# Modiste (CEPZ) Ltd.

Plot 1-4, Sector #6, Export Processing Zone, Chittagong

22 June 2014

## Movement Joint

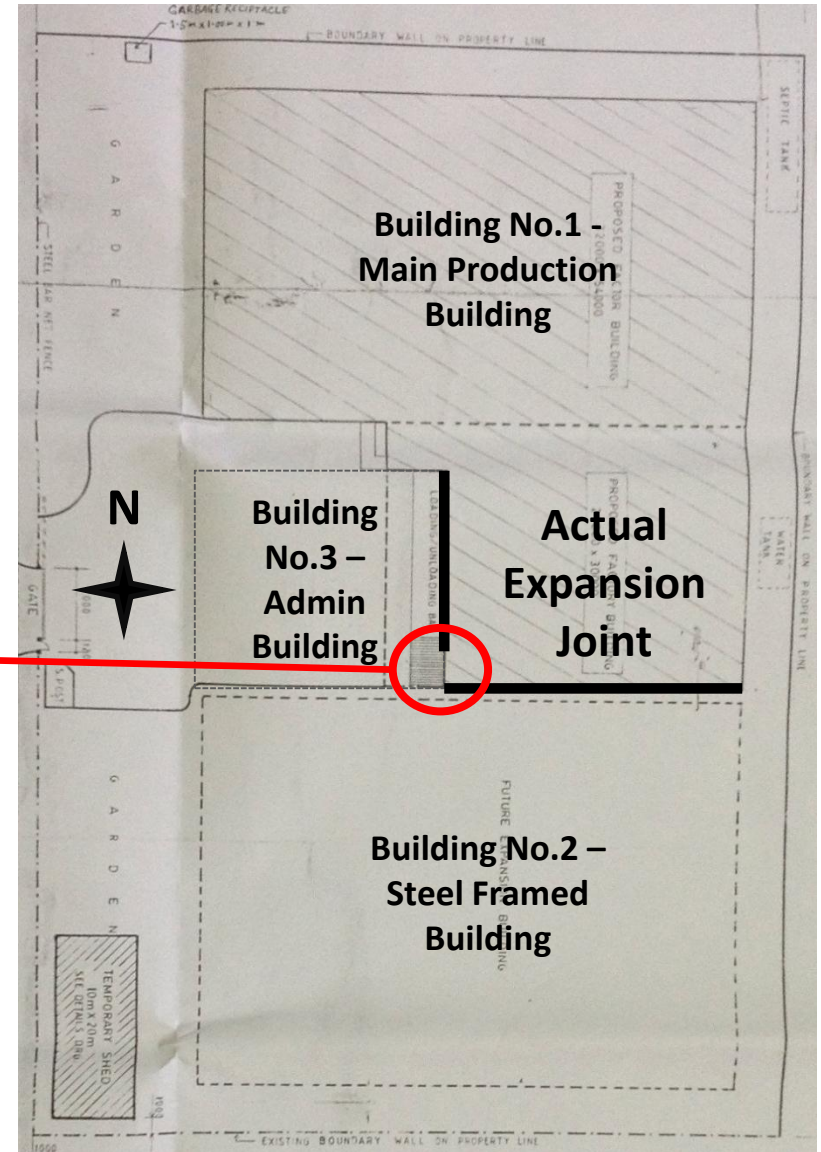
**Movement joint does not extend the full length between Building No.1 and No.3**

| Item No. | Observation                                                          | Recommended Action Plan                                                                                       | Recommended Timeline |
|----------|----------------------------------------------------------------------|---------------------------------------------------------------------------------------------------------------|----------------------|
| 10       | Movement joint between Buildings 1 and 3 is discontinuous            | Structural Engineer to determine the location of the interface between Building 1 and 3.                      | 6-months             |
| 11       | Movement joint between Buildings 1 and 3 is discontinuous            | Form a properly detailed expansion joint between both buildings as directed by the Structural Engineer.       | 6-months             |
